CONDEA VISTA COMPANY

**ABERDEEN EXPRESS, PHASE 3
ABERDEEN, MS**

PROCESS HAZARD ANALYSIS REPORT

RAYTHEON ENGINEERS & CONSTRUCTORS

P&ID
RECYCLED CENTRATE PROCESSING
Abundant Express Project - Phase 3
ID: DY-093149-PID-D

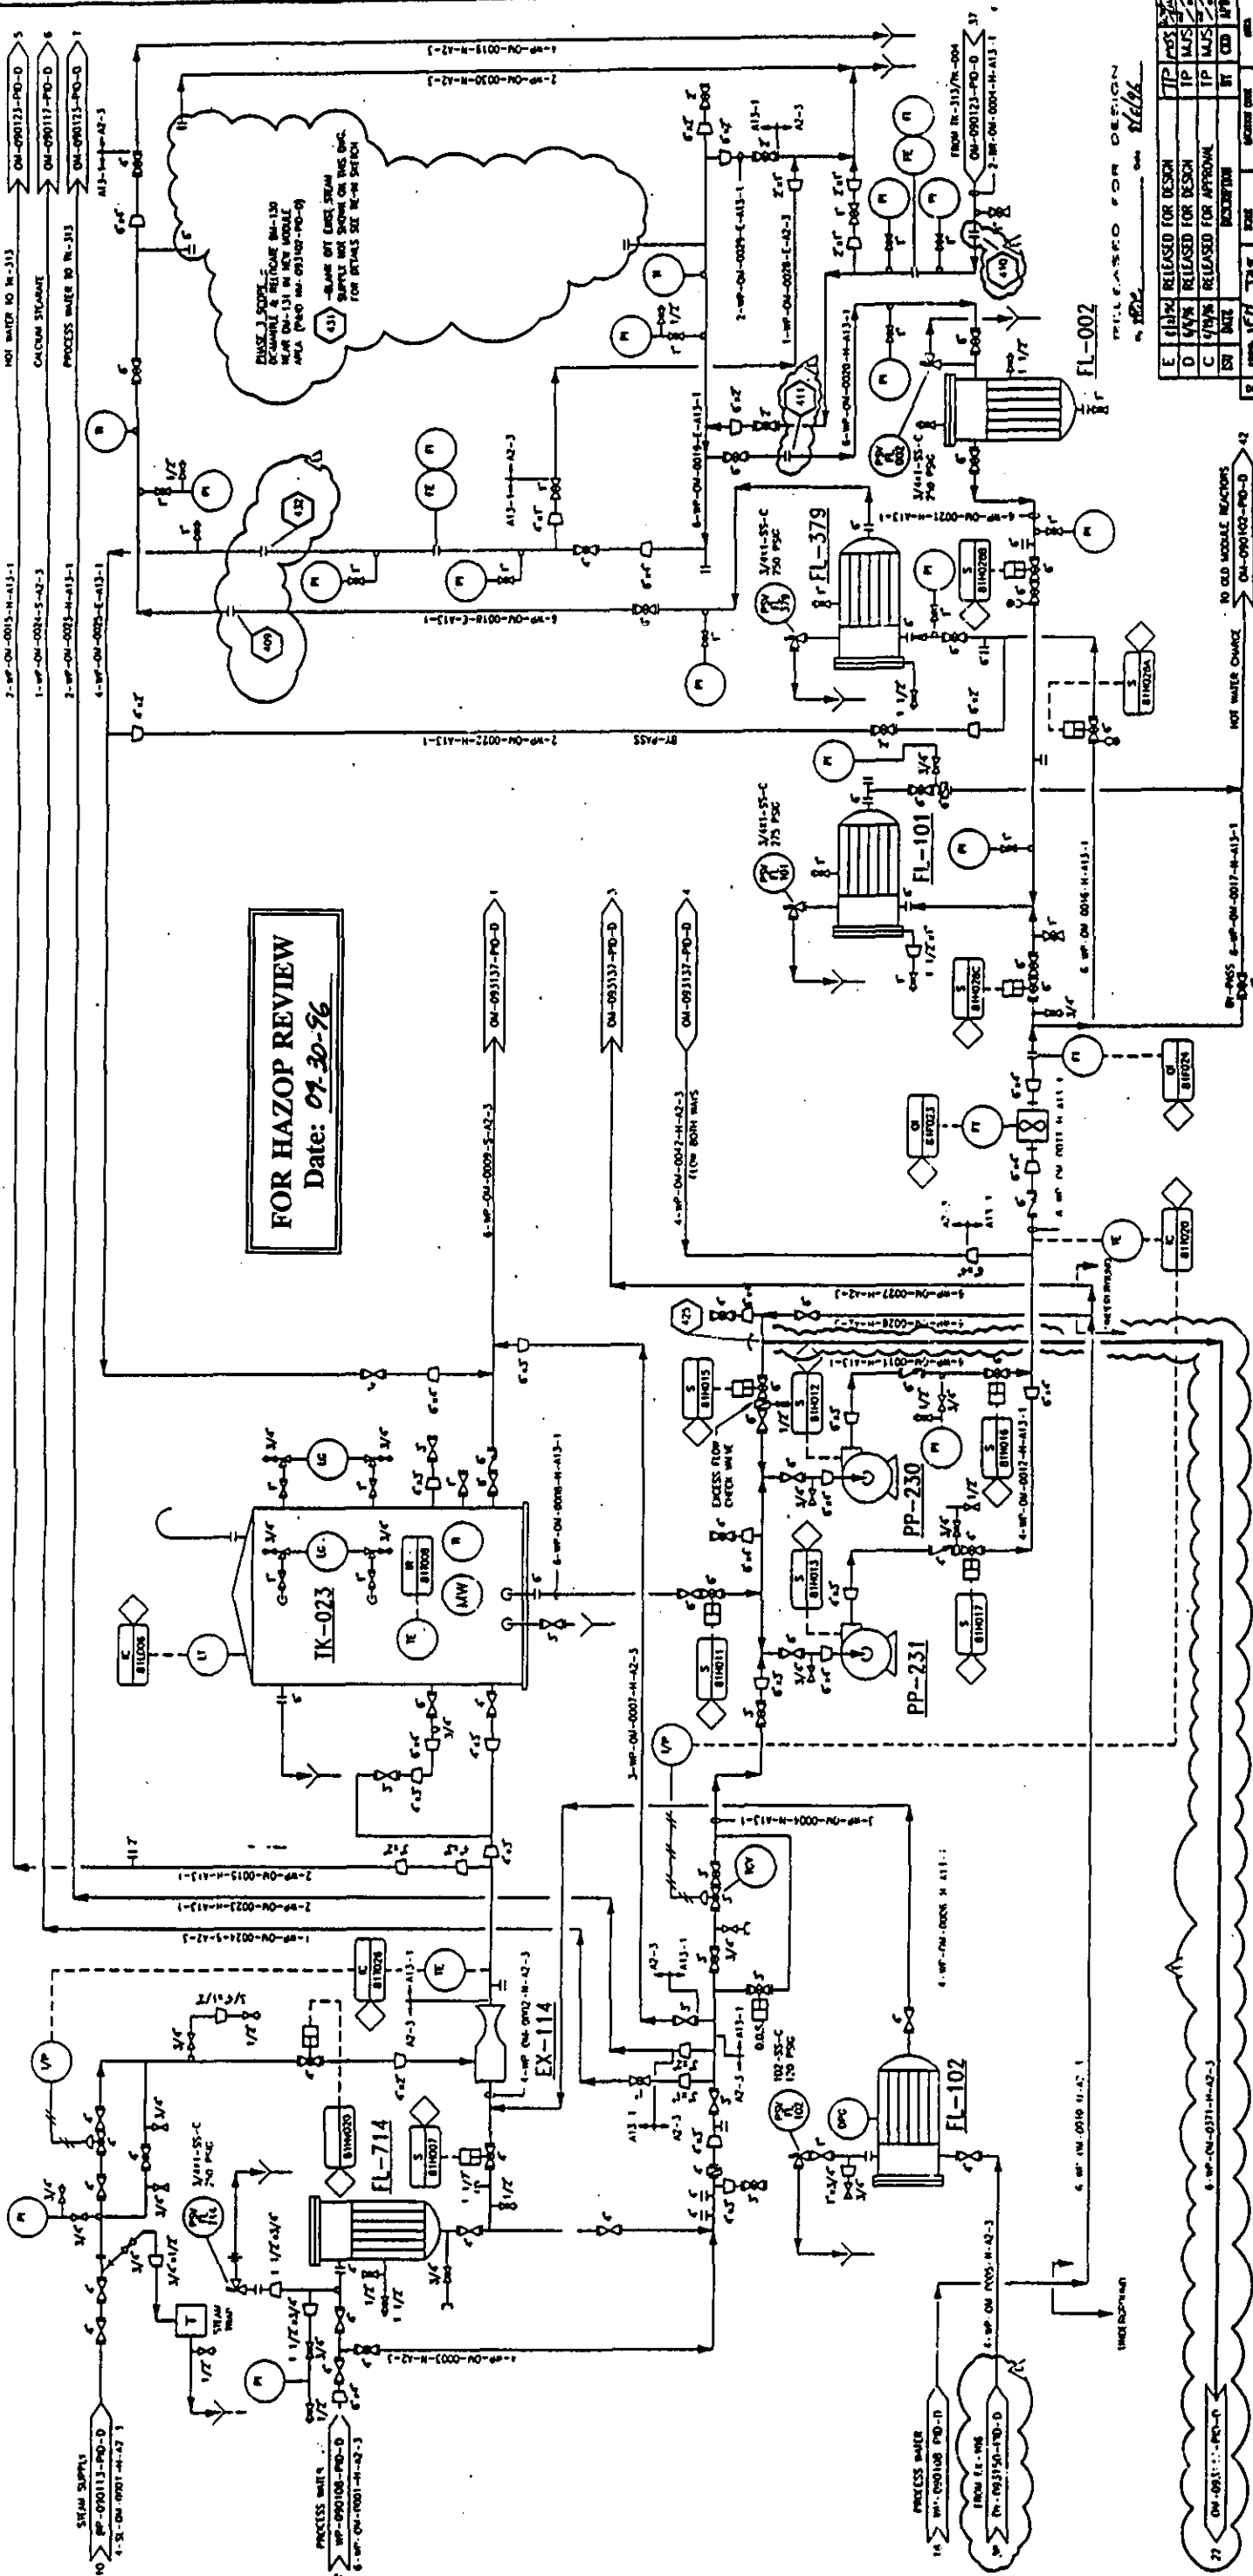
Item Number	Deviation	Causes	F C	Consequences	FXETIBO	Safeguards	Actions
339.0 PROCESS LINE - PLANT AIR FOR SCOUR (dwg: DY-093149-PID-D)							
DESIGN INTENTION: SUPPLY AIR FOR FILTER BED SCOURING

339.1	NO / LOW FLOW	Operator error: manual valve closed	4	Loss of scouring, incomplete backwashing	4.....	SOP, training	
		Loss of plant air	2			Pressure indication (84-PI-51002)

Reference Number	Priority	Action	Responsibility	Status
328 -1	6	For water recycle chemical additives, consider some type of coding system or operating method to prevent an operator from hooking the wrong tote. (Item: 328.5)	Reed MacKay	
329 -1	8	Verify freezing point of sodium hypochlorite and determine if freezing could be a problem (Item: 329.5)	Reed MacKay	
334 -1	8	Review MSDS of water recycle chemicals to determine proper handling procedure. (Item: 334.1)	Reed MacKay	
339 -1	7	When writing the program for the media filter system consider operation in case of loss of air during the air scouring step. (Item: 339.3)	Reed MacKay
